RM1-07/08
M1307.3.1

Proponent: John Stelzenmueller, City of Tualatin, OR, representing the Oregon Mechanical Officials Association

FIGURE M1307.2
MOTOR VEHICLE IMPACT PROTECTION

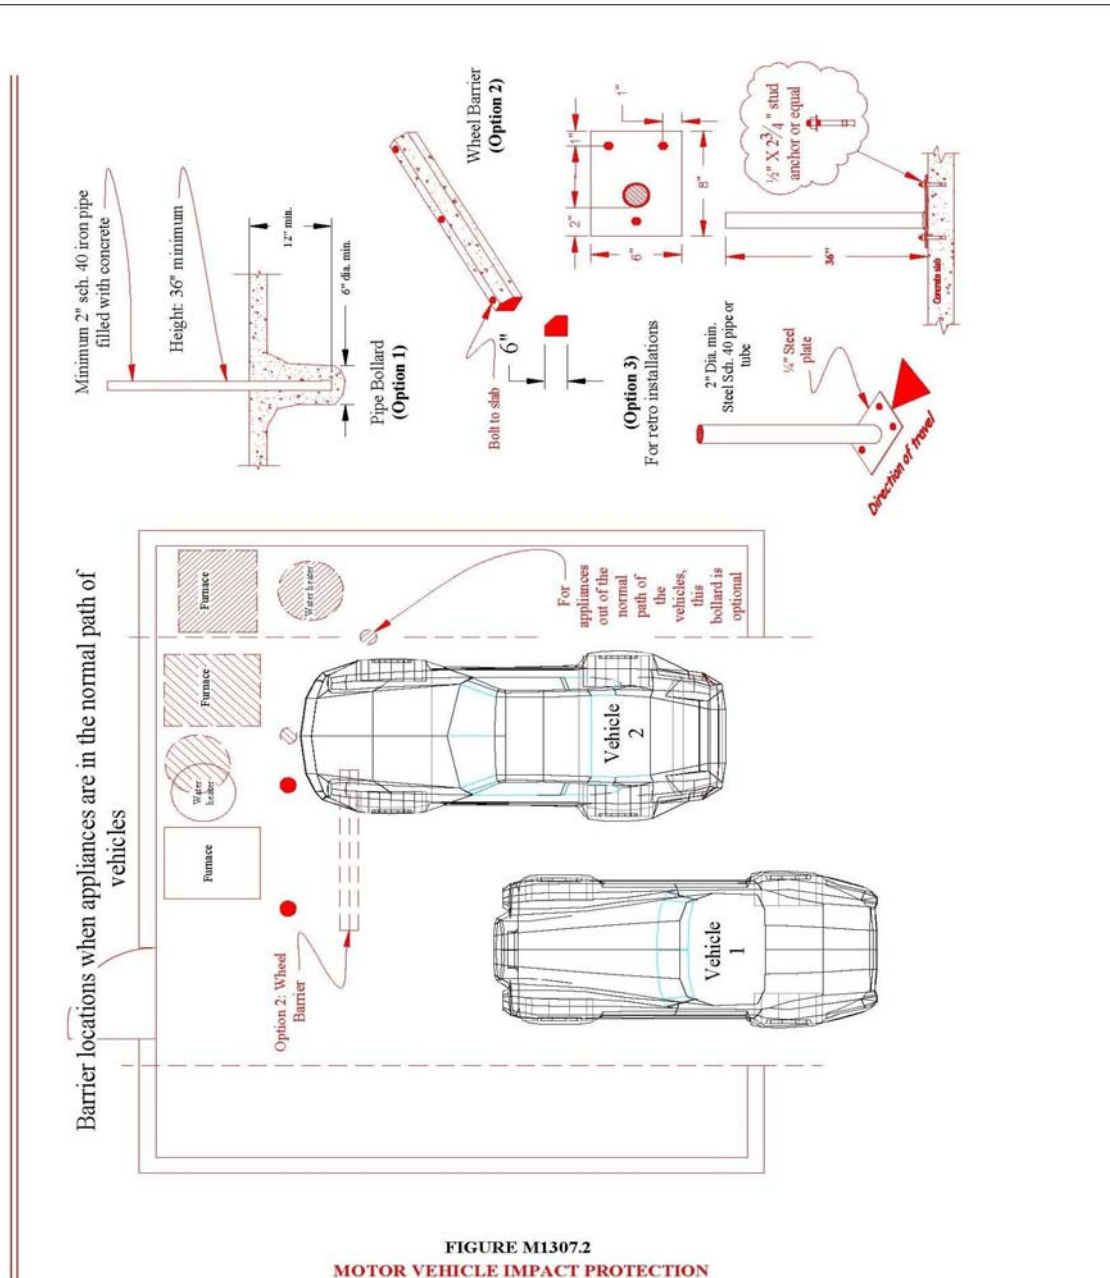
M1307.3.1 Protection from Impact. Appliances located in a garage or carport shall be protected from impact by automobiles in accordance with one of the types of protection shown in Figure M1307.2.

Reason: There are many scenarios associated with the installation of appliances in a garage and the exception to Section M1307.3.1 is unclear as to the type or location of appropriate protection. The addition of this figure will give the user of the code, whether an installer or inspector, some prescriptive guidance as to the type and location of suitable appliance protection.

FIGURE 1

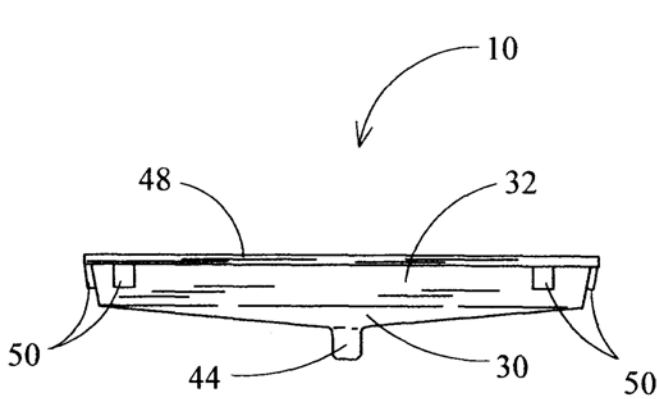
M1411.3.1 (Supp) Auxiliary and secondary drain systems. In addition to the requirements of Section M1411.3, a secondary drain or auxiliary drain pan shall be required for each cooling or evaporator coil where damage to any building components will occur as a result of overflow from the equipment drain pan or stoppage in the condensate drain piping. Such piping shall maintain a minimum horizontal slope in the direction of discharge of not less than 1/8 unit vertical in 12 units horizontal (1-percent slope). Drain piping shall be a minimum of 3/4-inch (19 mm) nominal pipe size. One of the following methods shall be used:

Reason: The purpose of the code is to clarify and add a new requirement upon the existing code as written. Residences today, have HVAC systems installed in the attics. The modification above will address a recurring problem which many homeowners face today. That is it will eliminate "flat bottomed pans" that do not necessarily allow for the drainage of condensate through the side outlet (which incidentally is on the side of the pan approximately 1/4 to 1/2 inch above the bottom panel). The proposed change will eliminate pooling of residual condensate, corrosion and in some instances microbial growth. To ensure complete drainage, pans must possess an "a contoured or sloped lower bottom surface with a drain outlet on its bottom panel".

See Figures 1 and 2 for details.
